**Intelligence Community Campus-Bethesda (ICC-B) :South Campus Improvements; Submittal #1, The Centrum Building and Illustrations of Future Submittals #2 and #3; Voluntary Submittal Following Mandatory Referral  
MR No. 2011105-MDP-4**

This is an advisory review of a *voluntary* submittal of design work to implement the master plan of the *Intelligence Community Campus-Bethesda (ICC-B)*, an existing Federal Facility that is being retrofitted by the Defense Intelligence Agency and United States Army Corps of Engineers (DIA/USACE). The campus is located at 4600 Sangamore Road and is approximately 30 acres. It is in the R-90 Zone within the Bethesda-Chevy Chase Master Plan area. This design work focuses on the South Campus. It includes conceptual designs for all future phases of the campus improvements as well as detailed designs of the Centrum Building (The Centrum). The latter will function as the main spine for internal circulation connecting all buildings. It will be approximately 225,000 square feet and provide campus-wide amenities and additional office space. This submittal was made April 12, 2013.

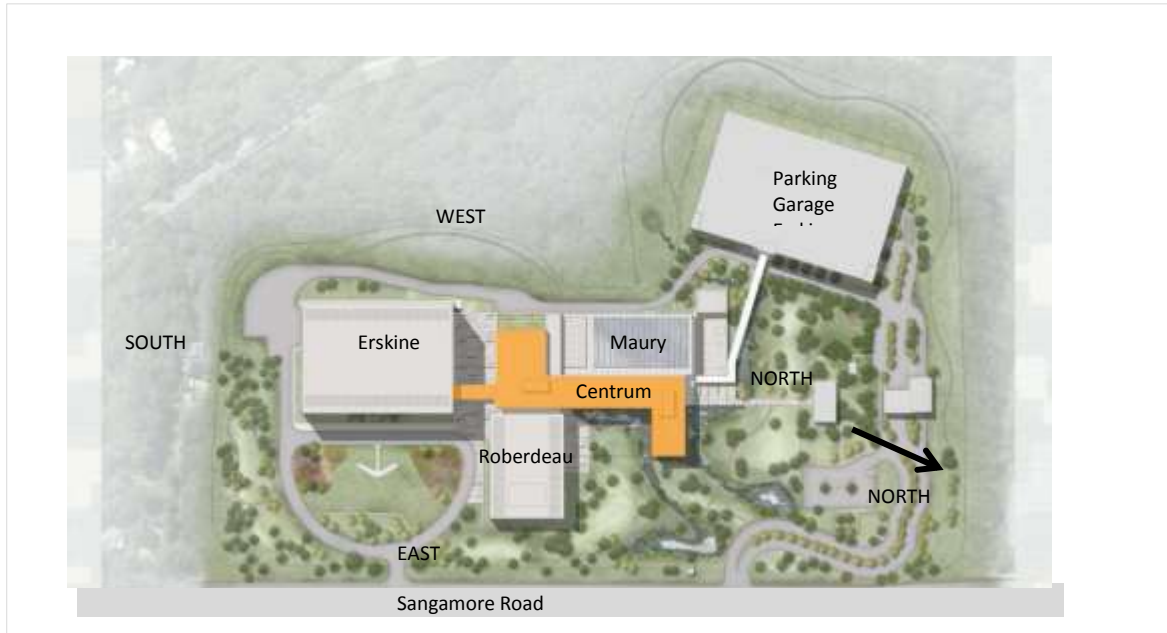
On upper levels of structures, the design concept is to clad portions of the buildings in prefinished aluminum panels in a variegated copper color range. The custom coloring and patterning to evoke tree trunks in woodland is an excellent concept and it results in a handsome design in the renderings. However, there are two concerns:

1. The inspiration for the patterning should be based on native trees that are common in this area rather than birch trees which are not found in the associated Potomac River stream valley buffer.
2. The coloring and patterned finish of the aluminum could produce unintended and unattractive results if not properly researched and tested thoroughly before hand, and adjusted accordingly.

The aluminum panels raise similar issue to that of the glass walls in terms of visibility. Color changes in appearance depending on the time of day and weather conditions. The design team has said that they will be testing the colors on the site and getting input from the community. Looking for built examples using similar materials and color variations for viewing at different times and under different conditions would be useful and is one way to see how color on a test panel might look when applied to a building.

1. Basing the inspiration for the patterning of the colored aluminum panels and the spacing and form of window openings on the facades, on native trees that are common in this area. The design should be carefully researched and tested locally before fabrication for construction. It should be adjusted as needed to ensure the desired results: attractive and not visually intrusive.

The design team should find ways to properly test and adjust the color. This should include testing both glass and aluminum panels and their appearance. Sharing built examples that use similar materials and color variations for viewing at different times and under different conditions is recommended.

EAST ELEVATION - Facing Sangamore Road

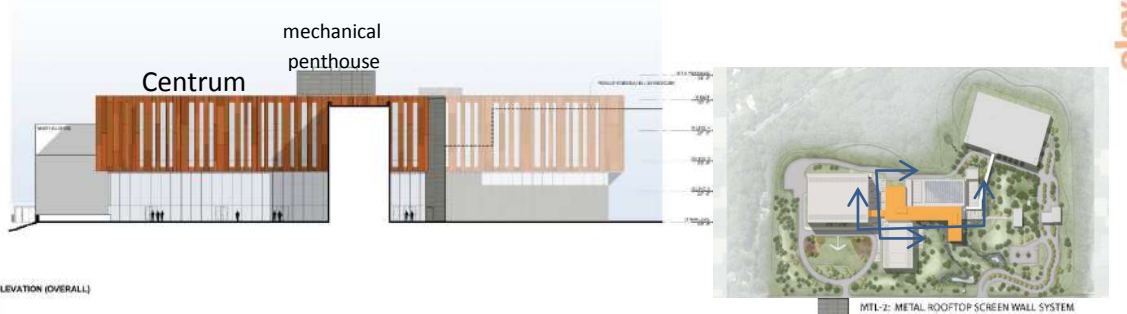
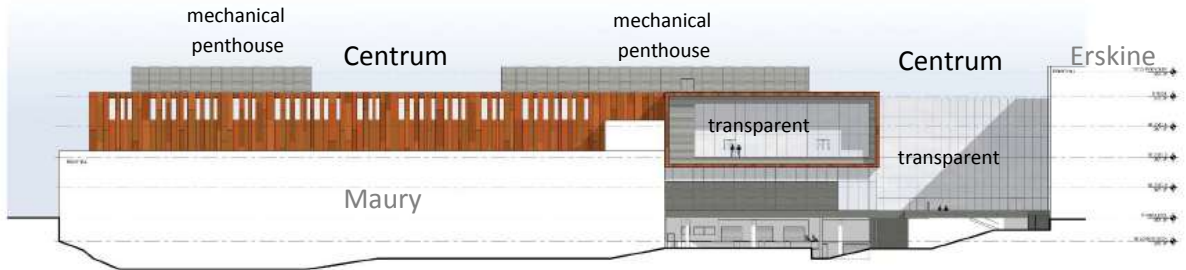
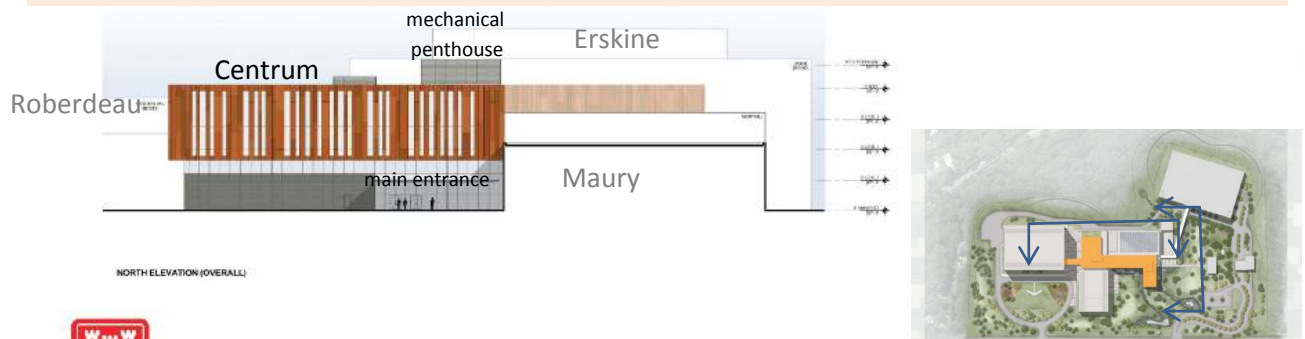
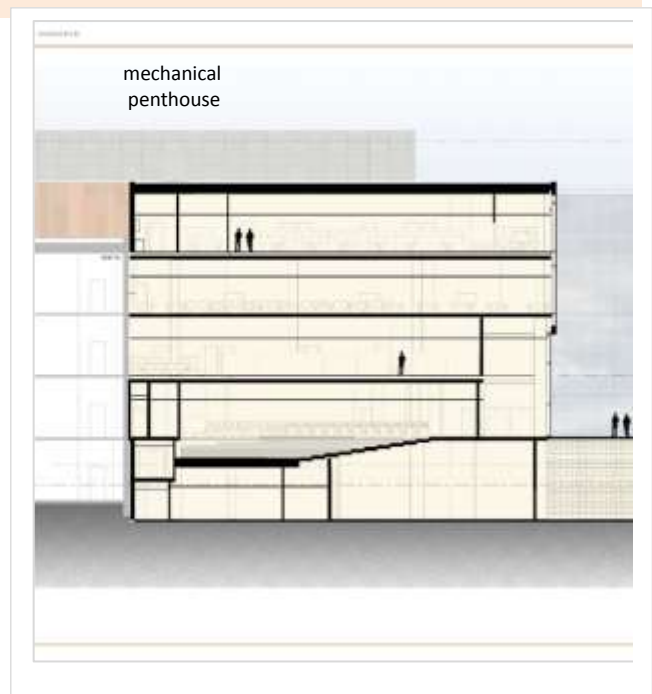
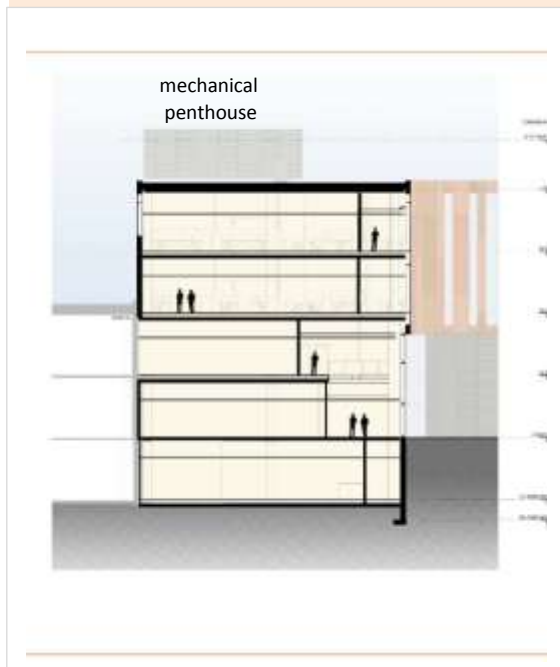
The following illustrations show the Centrum relative to Erskine Hall which is taller. There are two mechanical penthouses on the Centrum whose visibility should be minimized. This is also an NCPC recommendation.

The mechanical penthouses appear to add another full story to the building. They appear to run half the length of the Centrum. Consistent with the NCPC recommendation, the mechanical penthouses on the roof should be made less visible. There are a number of ways this could be achieved, including:

- Creating several penthouses instead of two long ones
- Placing mechanical equipment on a lower level roof
- Camouflaging the penthouses with a green vegetated screen or an appropriately patterned artful screen

2. Reducing the visibility of the mechanical penthouses, consistent with the NCPC recommendation; there are a number of ways this might be achieved. They include:

- Creating several smaller dispersed penthouses instead of the two larger ones ;
  - Placing some mechanical penthouse functions on a lower level roof ;

- Incorporating an expanded green roof in a manner that provides screening; and
  - Artfully camouflaging the mechanical penthouses. Consider a living green screen.
